Product Modifications and Additions

Series 36 Handle Improvements:

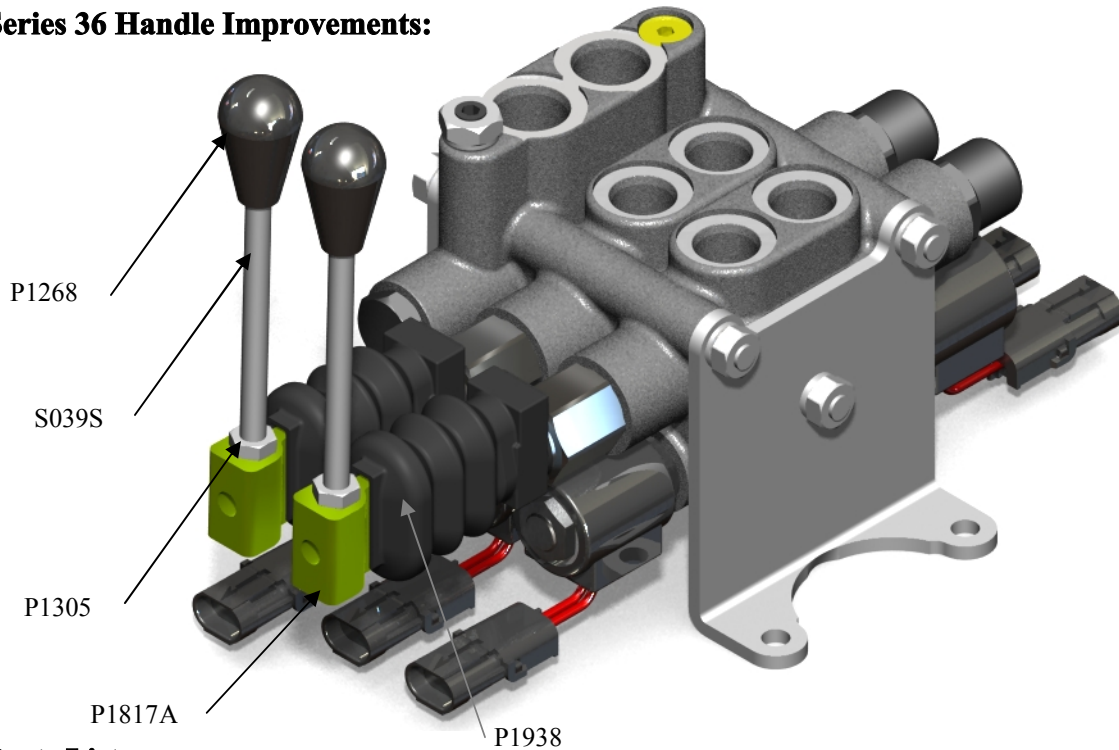
Brand Hydraulics has listened to its customers again, and increased the value of the Series 36/38 handle by designing a rubber boot to enclose the handle mechanism. This new handle uses an aluminum extrusion (P1817A) to link the two pivot points. The handle design has been rigorously tested and has only shown minimal wear. This improved handle design replaces our current design and does not increase the cost. It will replace the current design on March 2nd, 2009.

The enclosed handle functions the same as our current design as far as feel, travel, and shifting angle. It provides a cleaner look, keeps out contaminants and protects the spool. Please contact us with any questions on the new design.
